Response to Request for Review

Please find below the response to the request for review formulated for the CDM project with the registration number 1956. In case you have any further inquiries please let us know as we kindly assist you.

Response to the CDM Executive Board

Simplified electrical grid connection diagram

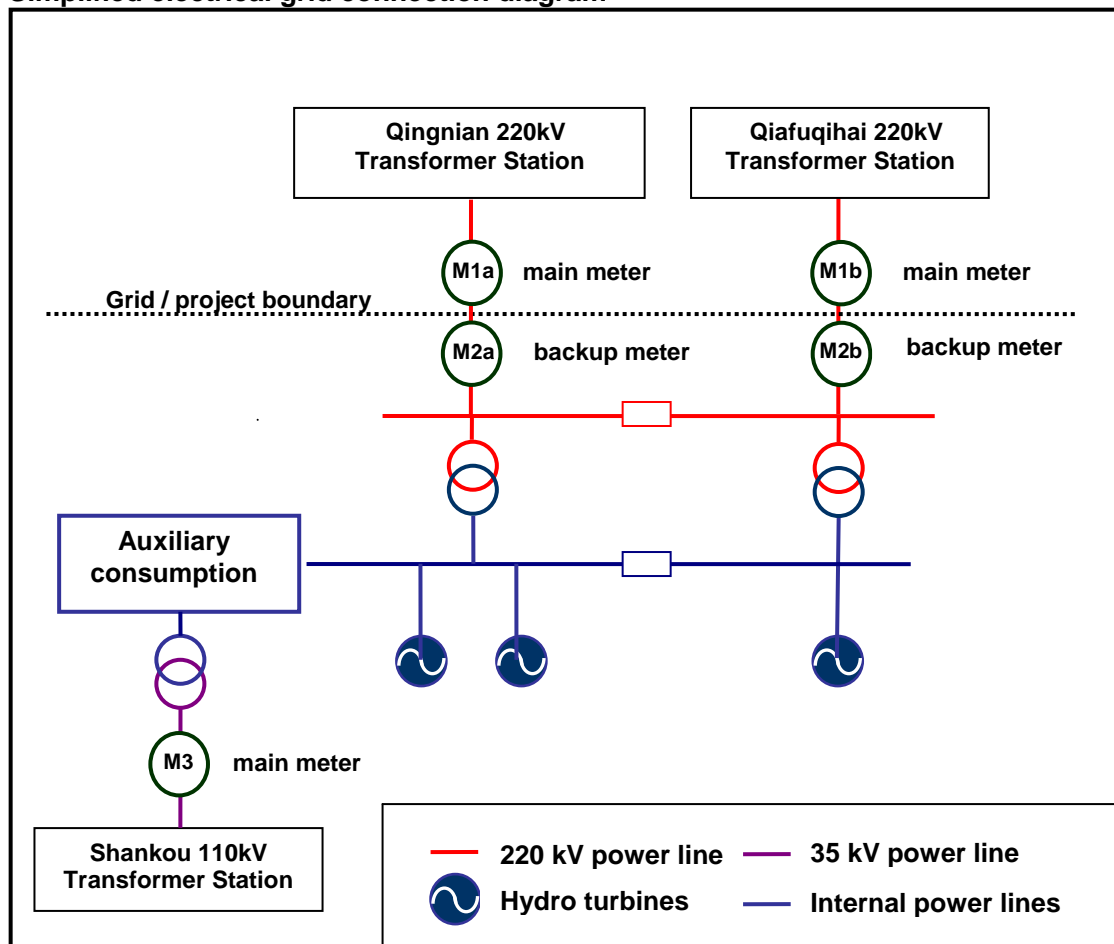
The monitoring plan should include the monitoring of the electricity transaction with each transformer stations (sub stations) separately.

The DOE should clarify how they have validated that electricity imports from the Shankou line, if any, will not be exported to Qingnian line and that corresponding CERs will not be claimed.

As indicated in the grid connection diagram, the proposed project activity is connected to the grid via three power lines.

Two main power lines, which are employed to supply power to the grid through two grid transformer stations (i.e. the Qingnian 220kV Transformer Station and the Qiafuqihai 220kV Transformer Station, both belonging to the Grid Company), are only for power supply to the grid from the project activity. Therefore, there is no electricity transaction between the two substations (i.e. the two grid transformer stations).

Additionally, one back-up power line, which is employed to import power from the grid through the grid transformer station (i.e. the Shankou 110kV Transformer Station belonging the grid company), is only for power import to the project from the grid company in case of emergencies.

The back-up power line will only be used in case of emergencies when power is imported to the project from the grid company. There is no direct electricity transaction between the three substations (i.e. the three grid transformer stations) as they are not directly connected to each other. In the highly unlikely event that the project activity would received electricity via the back-up power line and export this to the grid via any of the two main power lines, this would not effect the net power supply (M1a+M1b-M3) as power imports will be deducted from gross power supply to calculate net power supply (M1a+M1b-M3).

According to the information collected during the assessment, the net power delivered to the grid will be monitored as a result of the metering of the electricity delivered to the local grid through the two transformer stations (Qingnian 220kV Transformer Station and the Qiafuqihai 220kV Transformer Station) minus any occasional power imported from the Shangkou 110kV Transformer Station to the project. According to the diagram as presented in PDD (please see also above) any of the three connection points has its own meter which will monitor the related power transactions. In particular, meters M1a and M1b will monitor the power transferred by the project to the Qingnian 220kV Transformer Station and the Qiafuqihai 220kV Transformer Station respectively; the meter M3 will monitor the electricity that, in case of emergency, will be imported by the project from the grid company through the Shankou 110kV Transformer Station.

- ✧ Two main power lines to supply power to the grid (i.e. the Qingnian 220kV Transformer Station and the Qiafuqihai 220kV Transformer Station), which are used only for power supply to the grid from the project activity. Main meters are M1a and M1b will measure gross supply of electricity to these two main grid transformer stations respectively. Therefore gross power supply to the grid is the sum of the measurements of metering instruments M1a and M1b,
- ✧ One back-up power line from the grid (i.e. the Shankou 110kV Transformer Station), which will be used only for power imported by the project activity from the grid company in case of emergencies. Therefore total power imported by the project from the grid is measured by metering instrument M3.

$$EGy = M1a + M1b - M3$$

The electricity imported through the Shankou line (if any) will be deducted from the power delivered to the local grid through the Qingnian 220kV Transformer Station and the Qiafuqihai 220kV Transformer Station, according to the provisions in the monitoring plan.

With reference to the electrical grid connection diagram as in the monitoring plan of the PDD requesting for registration (see also above), any transaction from the Shankou line to the project activity will necessarily be monitored through the M3 meter operated by the grid company. The system in place, in other words, allows to identify any power transaction that might occur from the Shankou line to the project, without leaving any possibility of fraud or intent to deceive. According to this consideration, the DOE confirms that the monitoring plan is robust and transparent and allows to verify the amount of net power delivered to the local grid and the related claimed emission reductions with certainty and without any reasonable doubt.
